**VALUE ENGINEERING STUDY
OF
*SR 7 - ELLIOTT COUNTY***

STATE PROJECT NUMBER: 09-126.00

This Value Engineering report summarizes the results of the Value Engineering study performed by VE Group for the Kentucky Transportation Cabinet (KYTC). The study was performed during the week of December 1-5, 2008.

2. *Value Engineering Alternative Number 1*

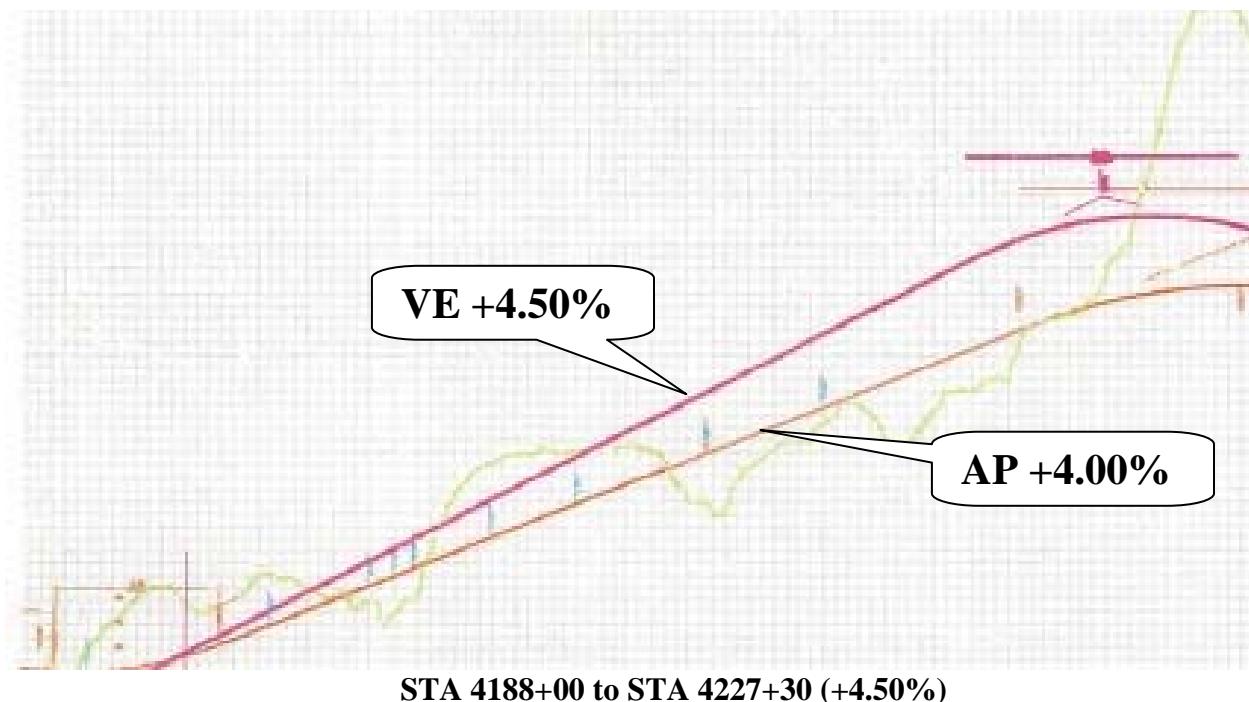
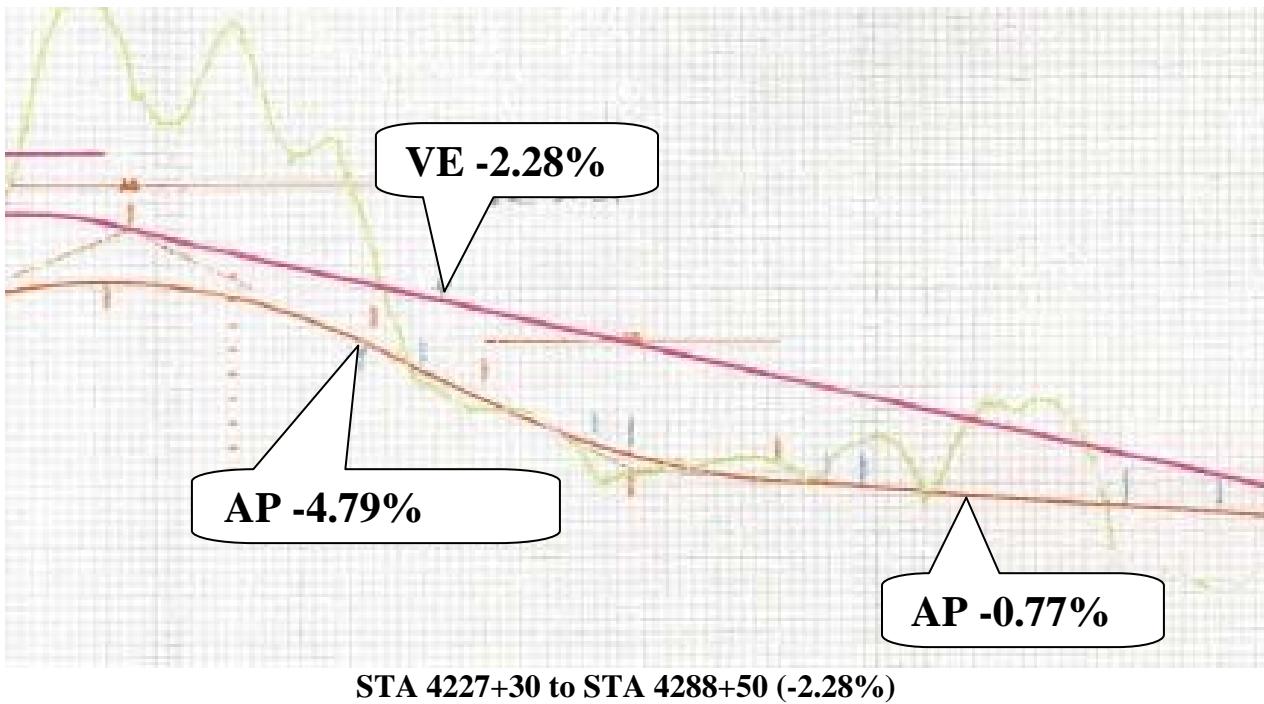
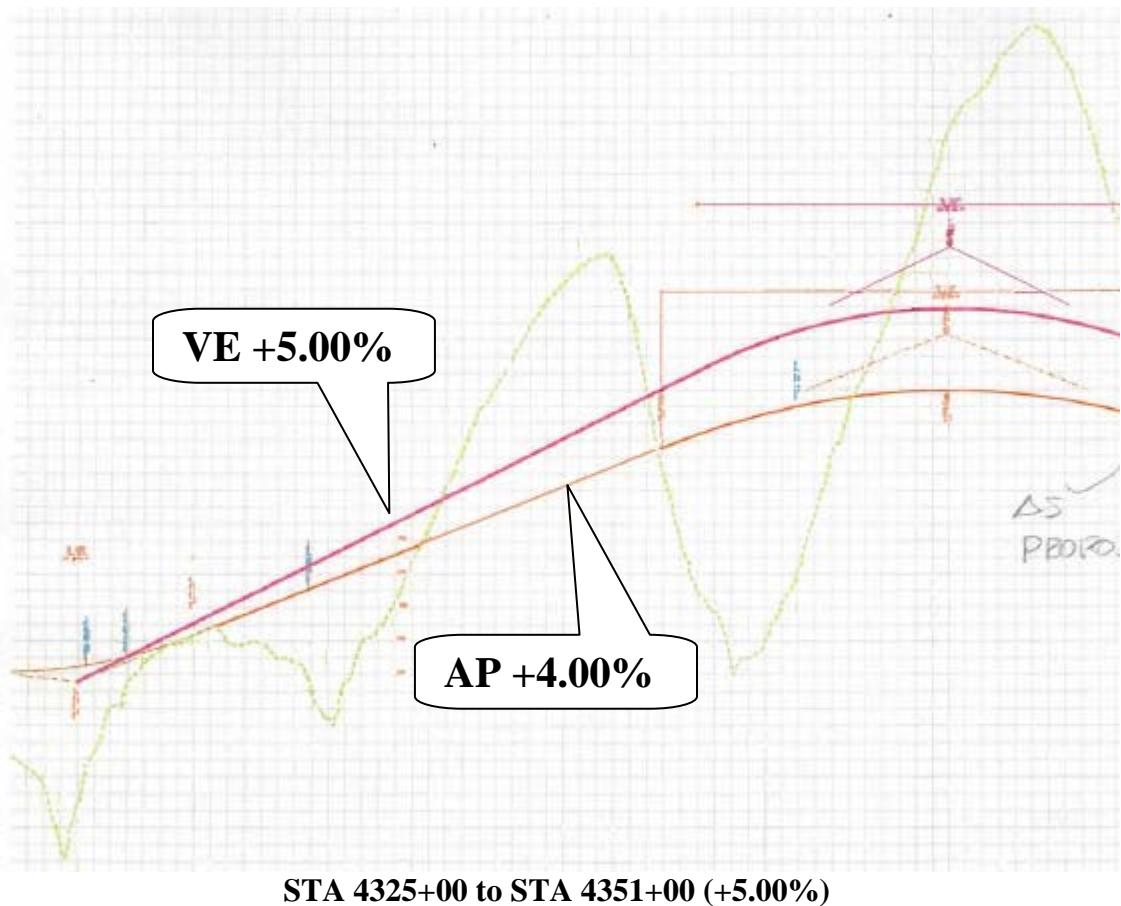
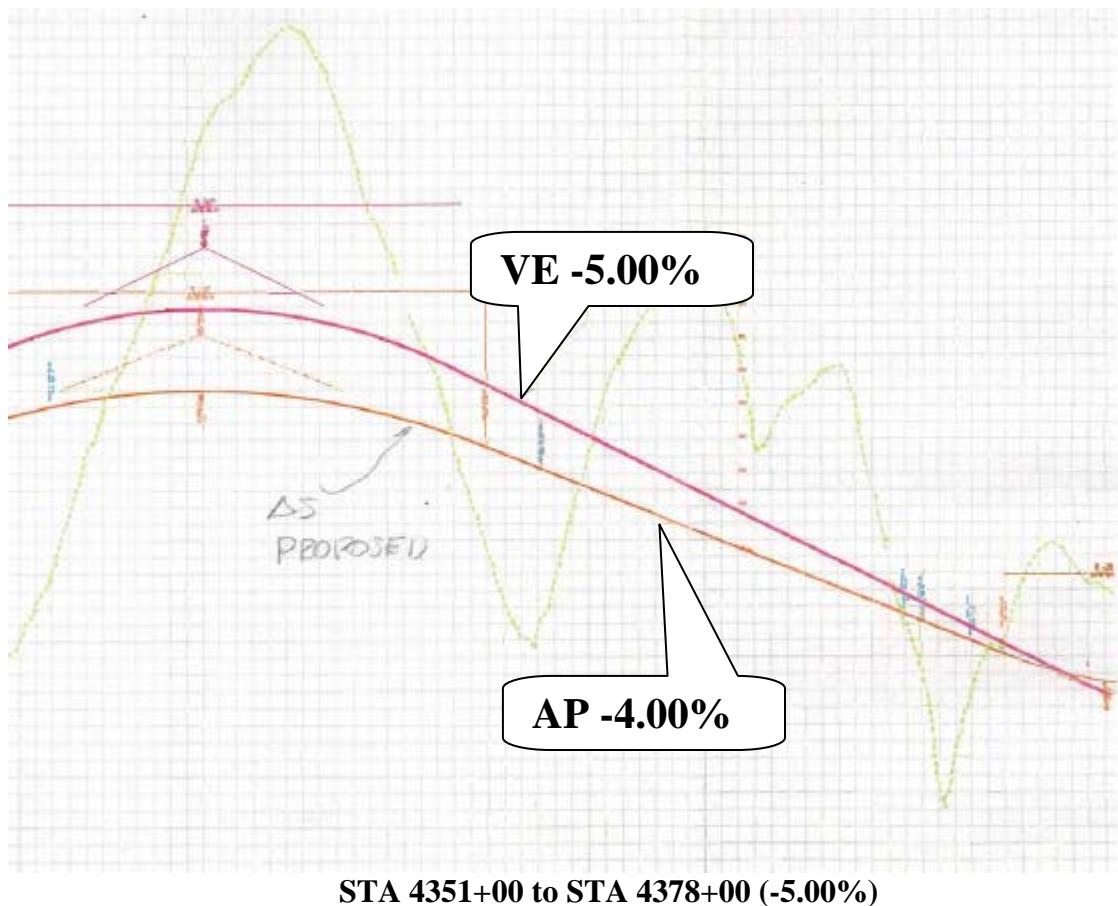
The Value Engineering Team recommends adjusting the grades to reduce the amount of waste on the project. It appears increasing the grades to the maximum 5% for this type of facility will reduce the amount of cut required in three locations:

1. STA 4188+00 to STA 4227+30 (+4.50%)
2. STA 4325+00 to STA 4351+00 (+5.00%)
3. STA 4351+00 to STA 4378+00 (-5.00%)

The grade from VPI at STA 4227+30 to an existing VPI at STA 4288+50 will be -2.28%. This grade passes through the existing VPI at STA 4234+00. Adjusting this grade will increase the amount of fill required and use more of the cut material to help balance the earthwork.

Adjusting these grades will significantly reduce the amount of waste disposal by the contractor and will also eliminate the warrant for a climbing lane from STA 4228+00 and 4260+50 where the grade is reduced to -2.28%.

TEMPLATE OF FALSE CUT

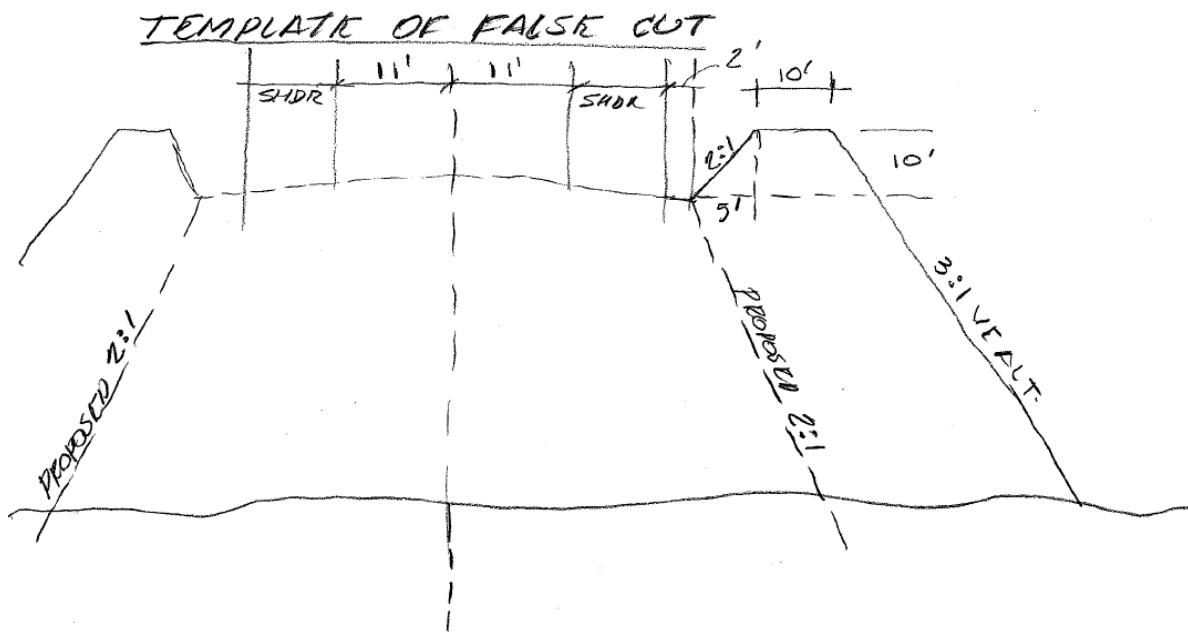
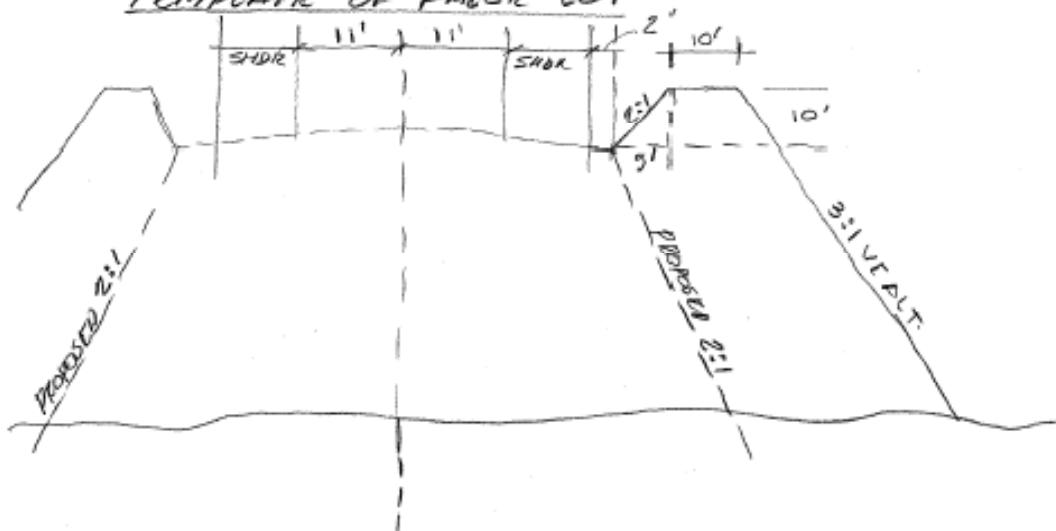
The “As Proposed” design has 3,842,988 cubic yards of waste that will have to be trucked off the site. A “False Cut” is actually a fill section that exceeds the fill requirements for the normal typical section and the roadway appears to be in a cut section. This section would be the same as the “As Proposed” to the clear zone, then a 10' high – 10' wide berm would be constructed with 3:1 side slopes to natural ground. This design provides additional areas to place excess material.

AS PROPOSED TYPICAL SECTION

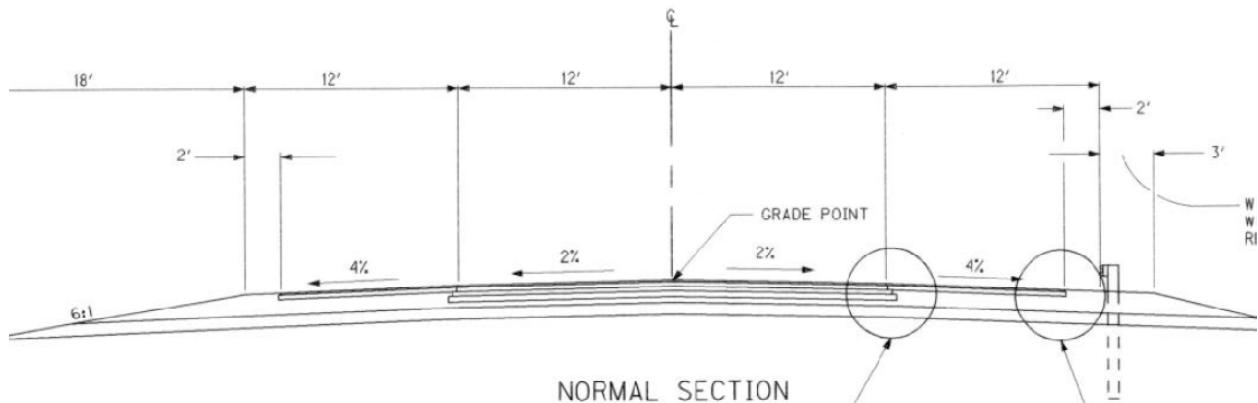
The "As Proposed" pavement design (preliminary) includes:

For a typical section of 2 – 12' lanes with 2 – 12' shoulders/ 10' paved.

Value Engineering Number 1 TYPICAL SECTION

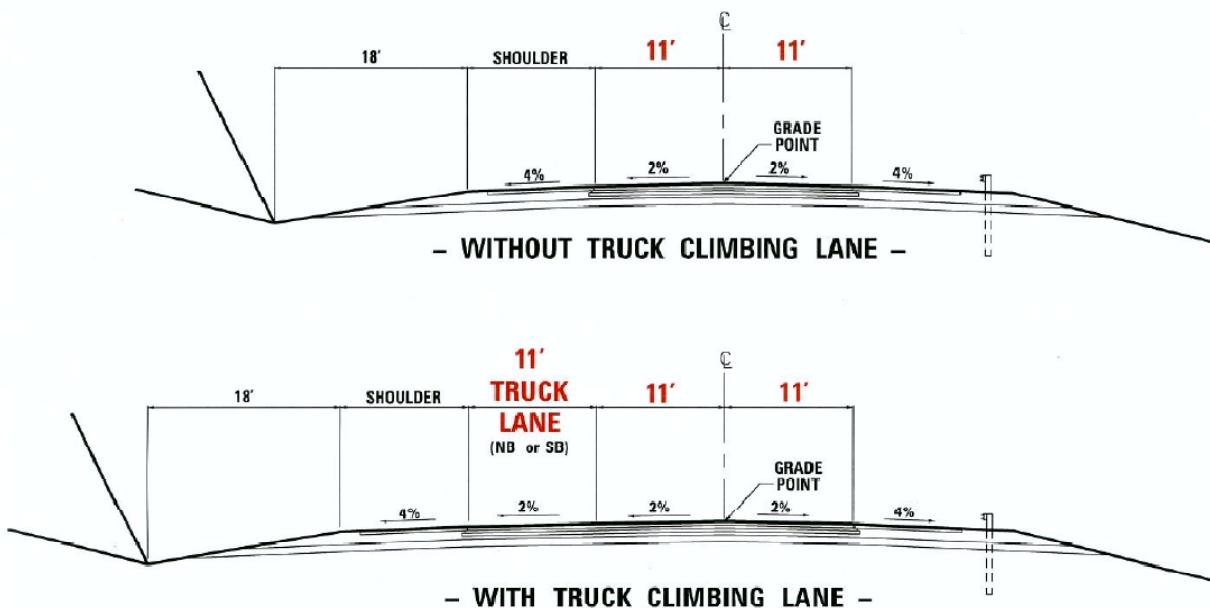
Value Engineering Alternative Number 1 will reduce the width of the Driving Lanes and the Truck Climbing Lanes. These lanes would be reduced from 12' lanes to 11' lanes resulting in a reduction in the Pavement Quantities and reduction in the Roadway Excavation quantity.

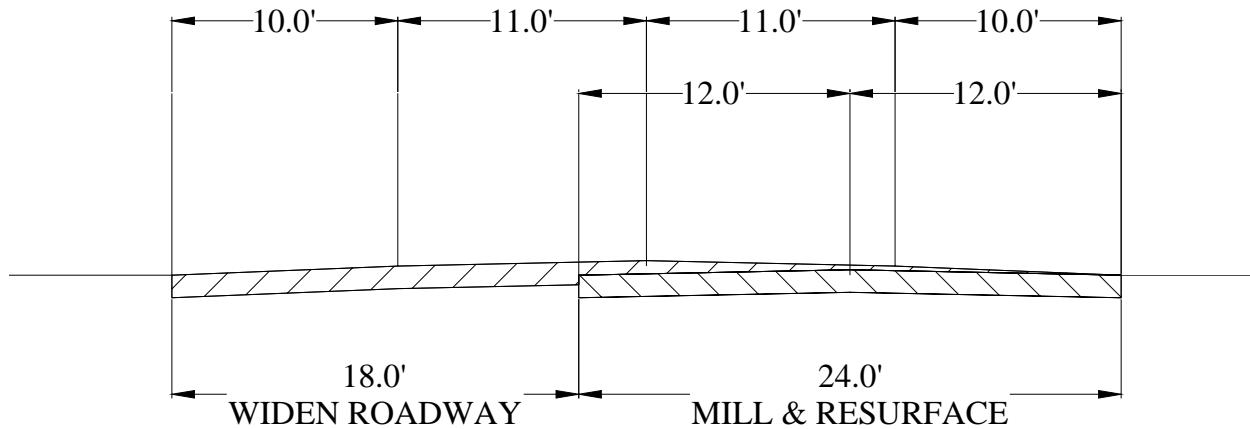
It was decided the Value Engineering Alternative Typical Section can be applied to the existing alignment from the beginning of the project to KY 409 by reducing the Design Speed to 45 MPH, and then raising the Design Speed to 55 MPH to the end of the project.

It is also understood there may be locations on the existing alignment that minor revision to the alignment may have to be made to meet the 45 MPH Design Criteria. The Value Engineering Team noticed the existing roadway is posted for a 45 MPH Speed Limit in the vicinity of the numerous residences located at the south end of the project. And north of the intersection of KY 409 would be a good point to increase the Speed Limit back to 55 MPH.

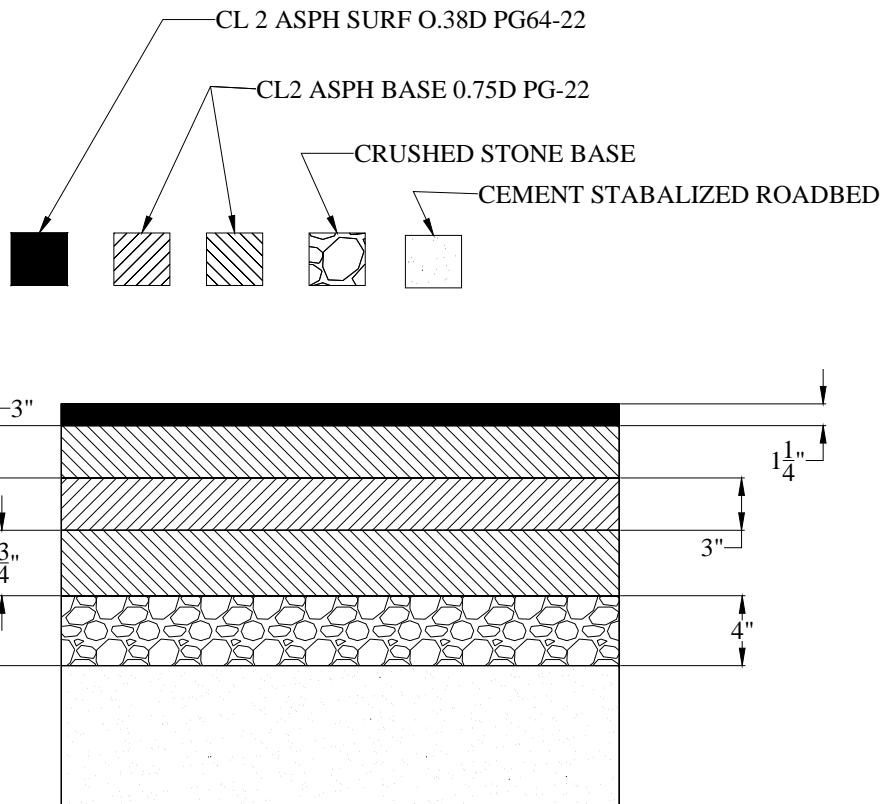
It is assumed the “As Proposed” pavement design will be bid for this project. In today’s markets the price of oil is very volatile, which creates a variation in the unit prices of materials used to pave the highway. The Value Engineering Team recommends that an “Alternative Pavement Design Bid System” be used to give the contractor the opportunity to bid the lowest priced pavement that he can provide at the time of the letting.

This system would provide the quantities for each of the 3 equivalent alternatives:

- Maximum Asphalt pavement design
- Maximum Aggregate pavement design
- Concrete pavement design

This system allows the contractor to bid the lowest pavement design he can provide based upon the economic conditions at the time of the bid. KYTC’s pavement design analysis spread sheet identifies the Maximum Asphalt Design as the most economical with the unit prices provided, but a contractor may use entirely different unit prices for his favored pavement design.
